**Re: ODOARDI – Vacant Lot
22 Nethermont Ave. – New House Construction
Tax ID: Section 122.16 – Block 4 – Lot 7**

This letter accompanies a revision to the plans, in response to the draft resolution received from the Planning Board Staff and Town Consulting Engineer.

Site Plan and Tree Removal Permit Approvals for

Odoardi [19-039]

Subcatchment Pre Dev: Ledge

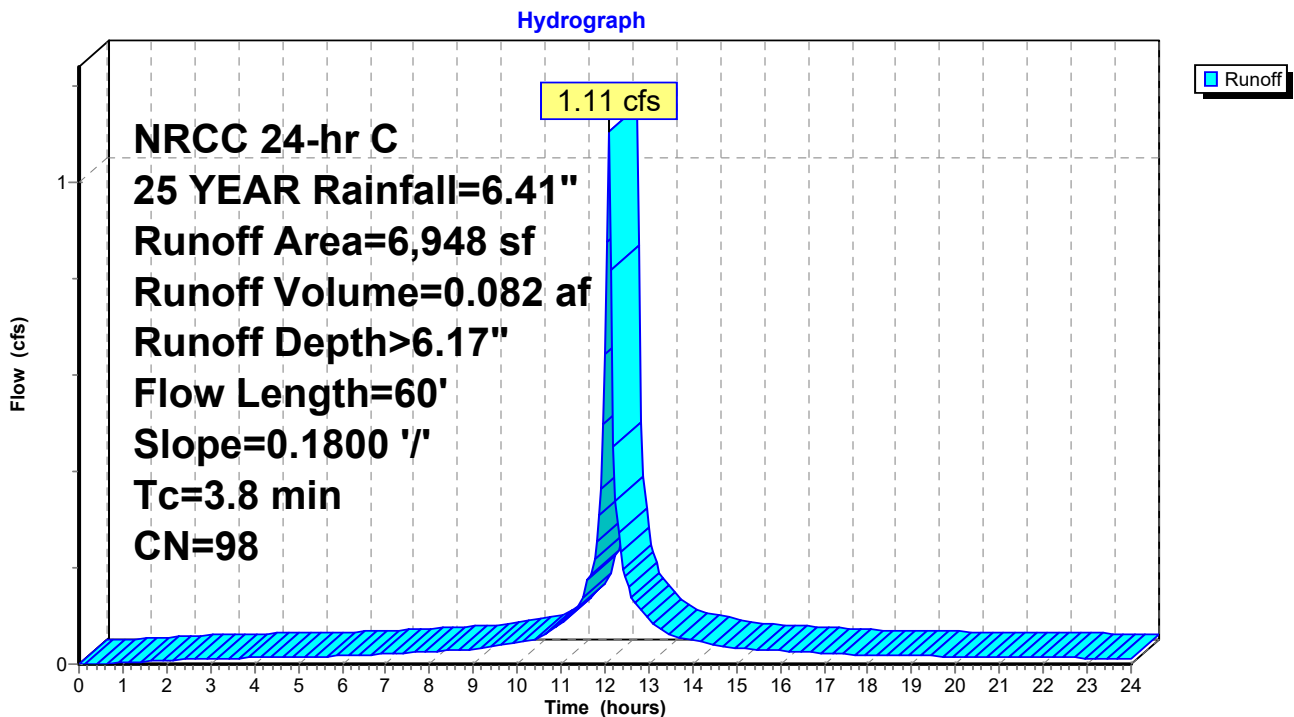
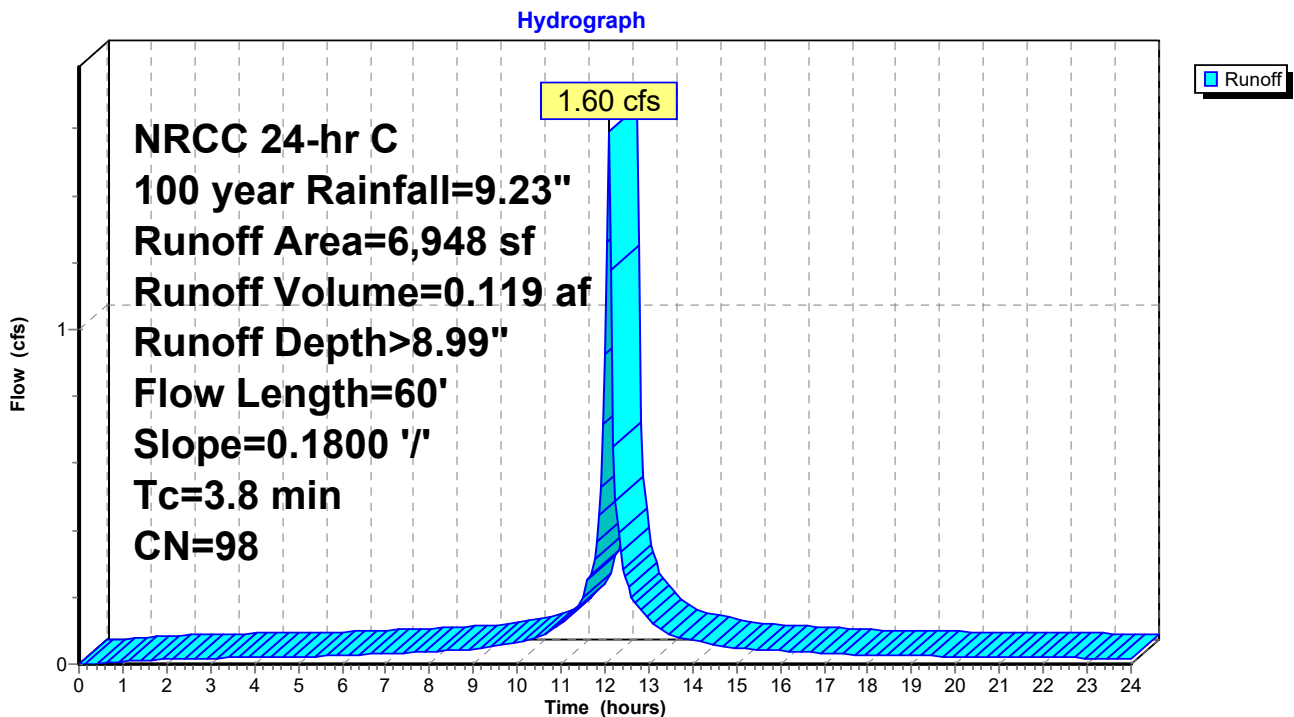
- _____ 5. The applicant has provided stormwater mitigation design calculations proposed to mitigate the net increase in runoff generated for the 100-year, 24-hour design storm event. The curve number for ledge (pre-developed) shall be revised to a CN of 98. The land areas used in the model shall be revised, as necessary to the satisfaction of the Town Engineer. All invert elevations for the components of the stormwater detention system and outlet structures shall be coordinated between the plan, details and the calculations to the satisfaction of the Town Engineer.

The CN number for the pre development has been revised to 98.

GRADING & STORMWATER PLAN

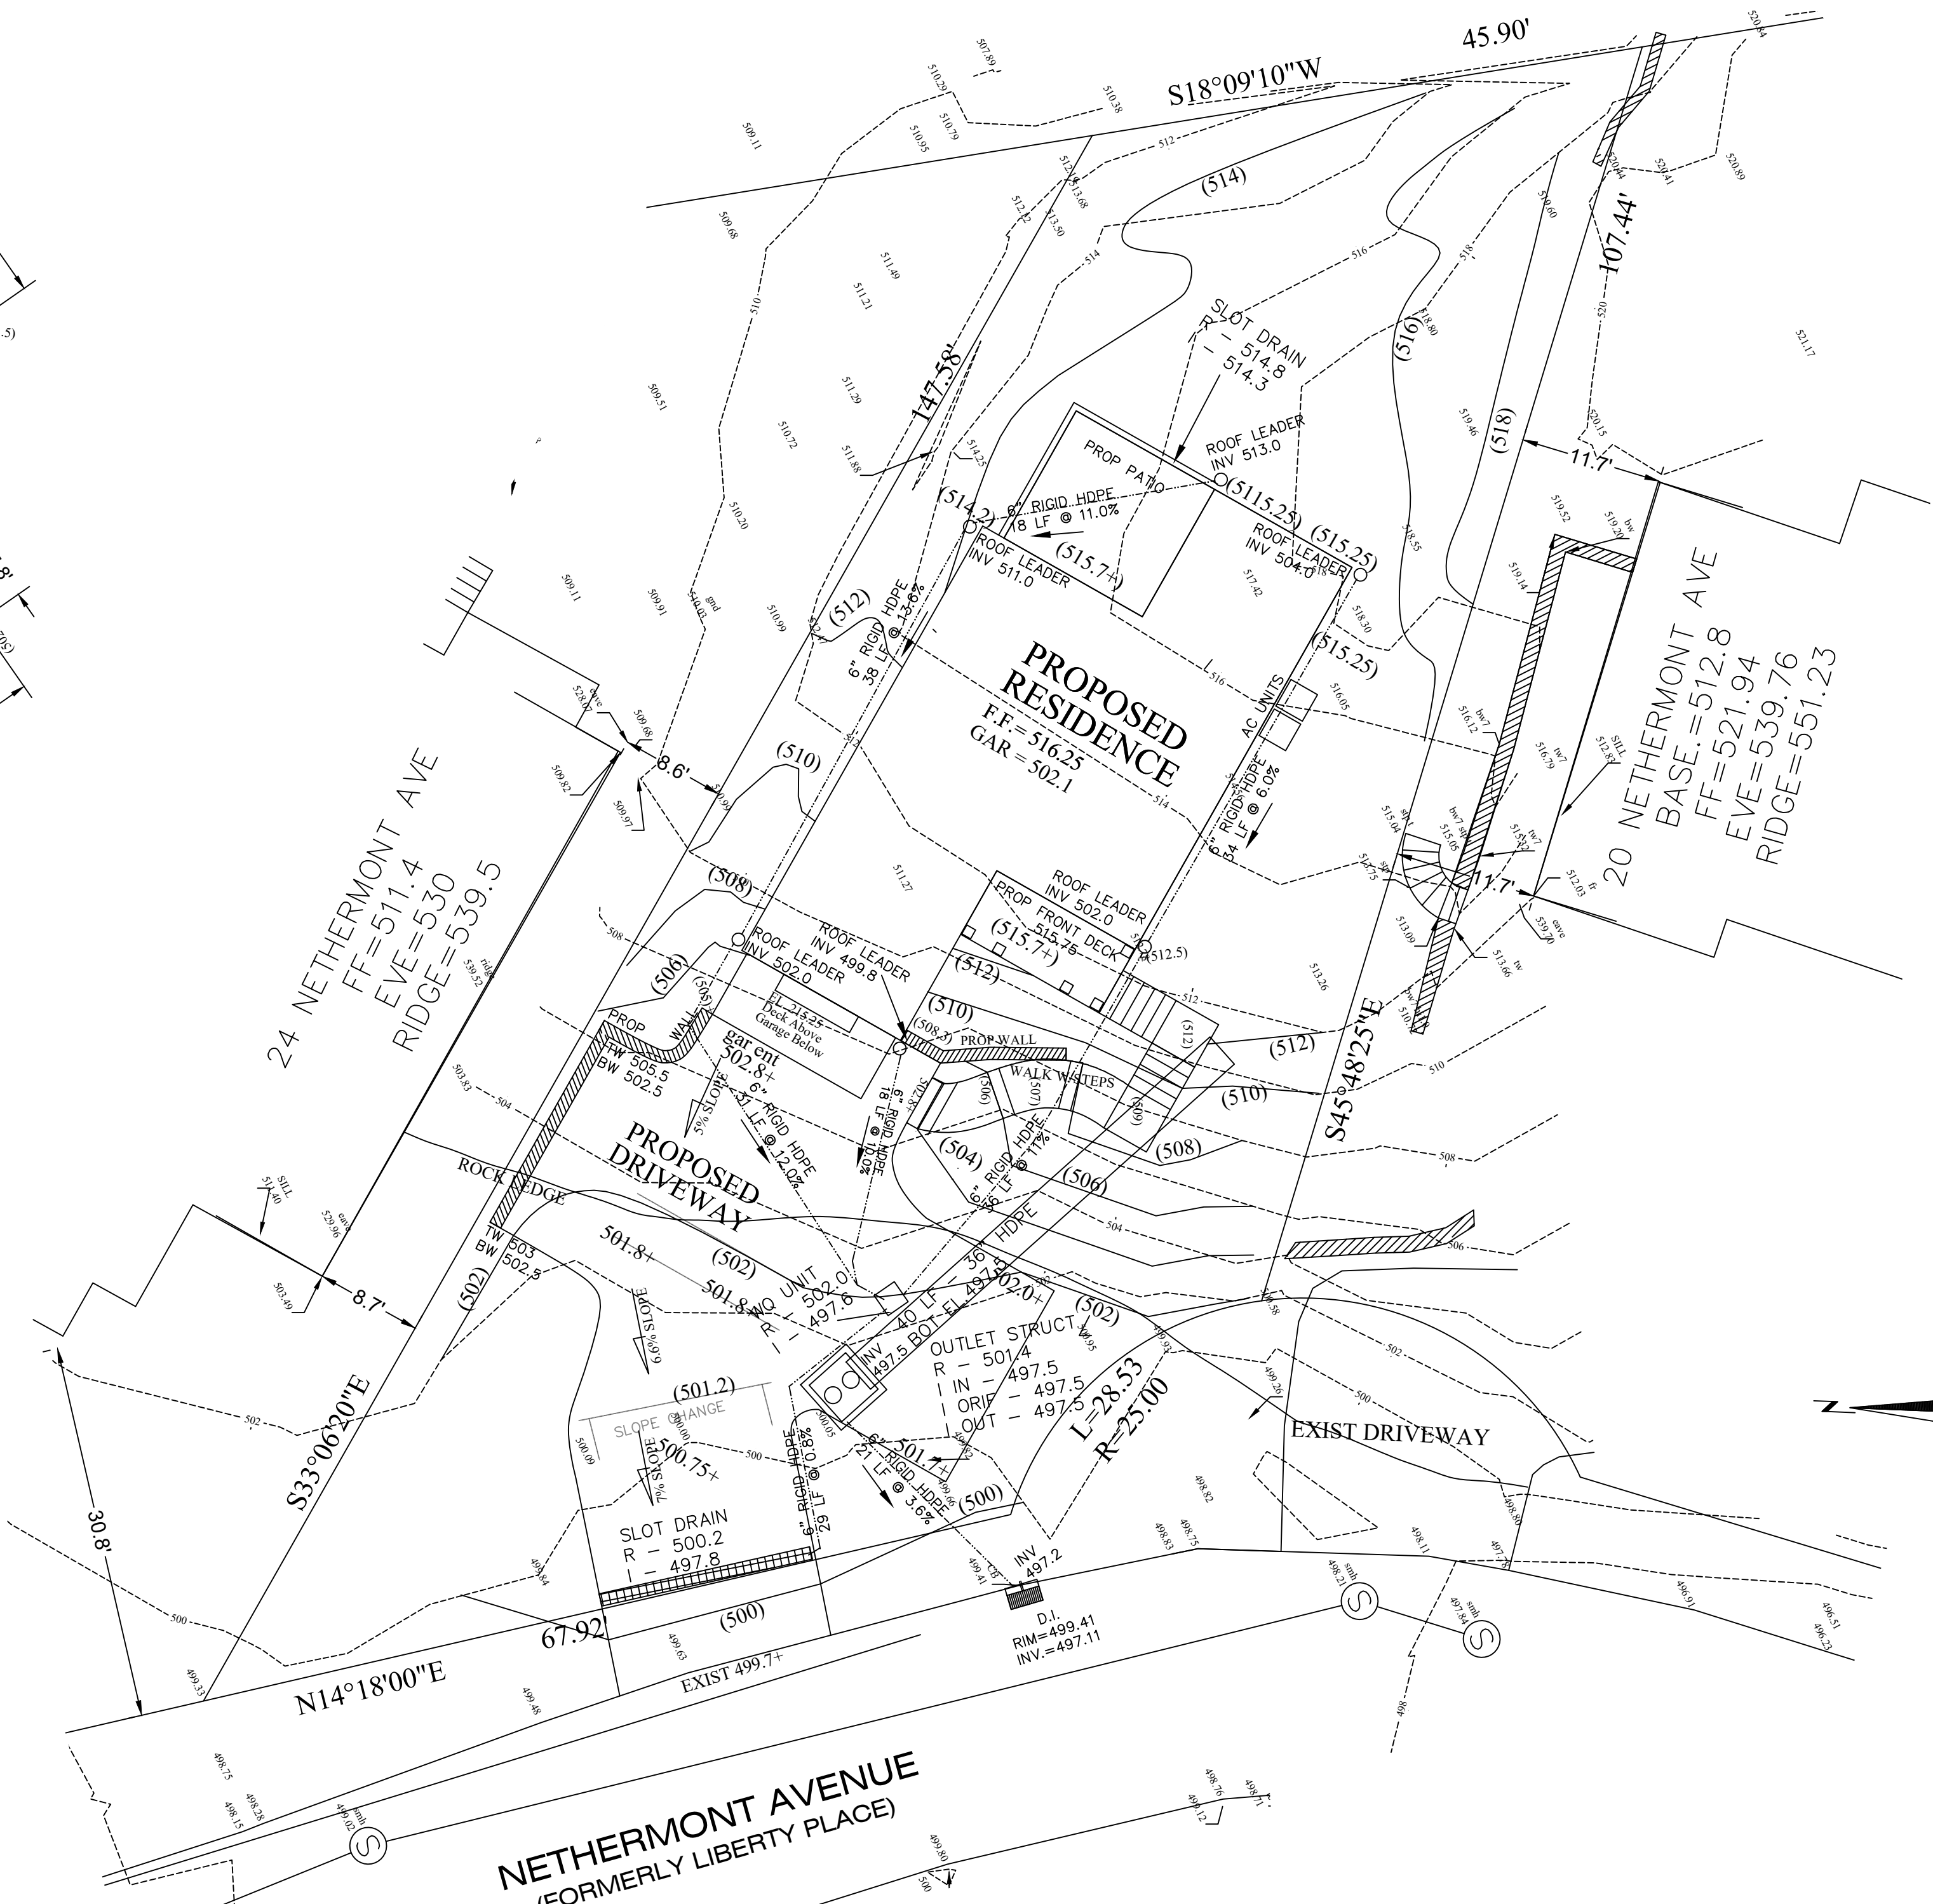
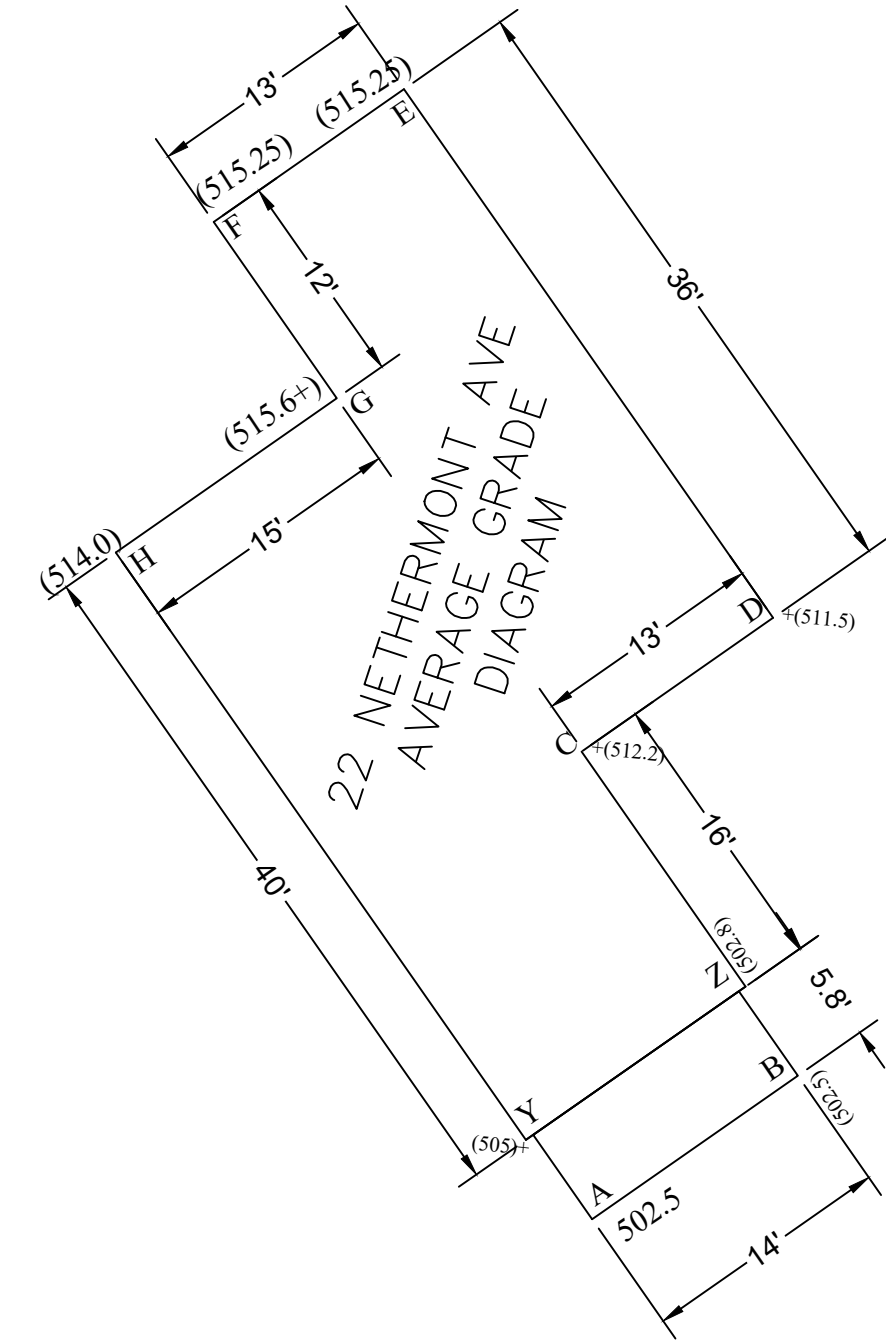
_____ 2. The Applicant shall demonstrate how average grade was calculated to the satisfaction of the Planning Department. The Town Code requires where the finished ground level slopes away from the exterior walls, the average grade shall be the lowest point within six feet of the perimeter of the building.

See grading and stormwater plan sheet 2 of 7
